2022/5492/P – 125 Finchley Road, NW3 6HY

Delegated Report Analysis s		et	Expiry Date:	08/02/2023 11/03/2023		
(Members Briefing)	N/A / attached	N/A / attached				
Officer		Application N	umber(s)			
Miriam Baptist		2022/5492/P				
Application Address		Drawing Numb	ers			
125 Finchley Road London Camden NW3 6HY		See Draft Deci	sion Notice			
PO 3/4 Area Team Sign	ature C&UD	Authorised Off	icer Signature			
Proposal(s)						
Alterations and replacement of space. Creation of roof terrace condenser units on rear flat roo second floor to the front and rea	at first floor level on f with new plant end	existing rear flat losure. Replacen	roof and replacer nent of all window	ment of existing		
Recommendation(s): Grant	t planning permiss	ion				
Application Type: Full F	Full Planning Application

6. Officer photo taken of existing plant scattered on first-floor flat roof

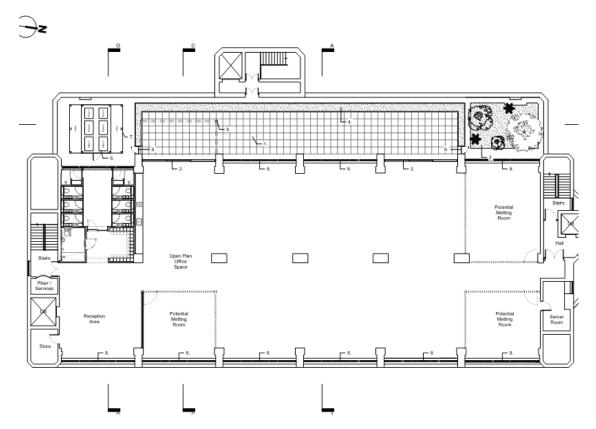
Proposed plant – very large, unsightly box whose bulk, heat and noise will affect flats above. Noise Impact Assessment refers to many nearby properties but not to the flats directly above.

Officer response: The Noise Impact Assessment has now been revised to refer to and take into account the flats above, and to address other issues raised. The council's Environmental Health officer has reviewed the application and deems the works acceptable and not of material harm to the surrounding residential properties. Conditions will be added to the permission if granted ensuring the relevant standards are met. While the enclosure is large it is serving large office floorplates and will ensure plant is properly attenuated which is an improvement on the previous/existing situation. The enclosure will be of a metal finish which is considered appropriate for mechanical plant and will not draw undue attention to itself.
